Index 550-011 Bridge Fencing on a Parapet (Curved Top)

BRIDGE FENCING ON PARAPET (CURVED TOP)

INDEX SHEET 550-011

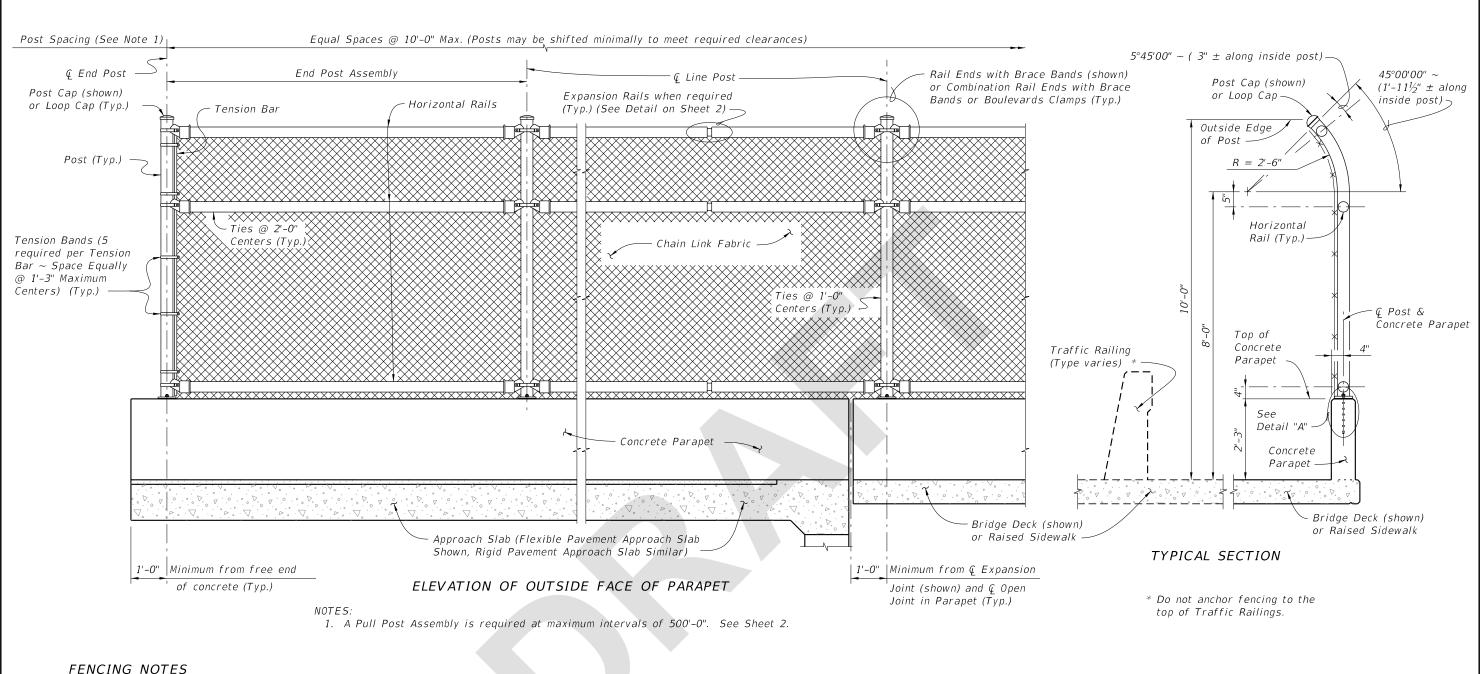
COMMENT: Please reconsider the RENAMING of these Indexes.....to avoid confusion.

Index 550-010 (which is not being revised) shows vertical bridge fencing on Traffic Railing Barrier and on Concrete Parapet.

The revisions propose to RENAME:

Index 550-011 to "Bridge Fencing on Parapet" Index 550-103 to "Bridge Fencing on Barrier"

Such that it is confusing how these Indexes are different from 550-010...or are meant to supplement 550-010.

In addition, FDM Section 222.4.1 and Figures 222.4.2 thru 222.4.8 include similar details and "sidewalk" terminology.....that should be coordinated with these proposed revisions to the Standard Plans. Please let me know if any questions.

RESPONSE: Agreed. Will rename 550-011 to "Bridge Fencing on a Parapet (Curved Top)" and 550-013 "Bridge Fencing on a Barrier (Curved Top)" in order to distinguish them from the Vertical version. The term "pathway" was used as a more general term to encompass both sidewalks and shared use paths that may be used with this Standard. We did not want to limit to either a sidewalk or shared use path.

CHANGE MADE TO INDEX: Yes; 550-011 was renamed
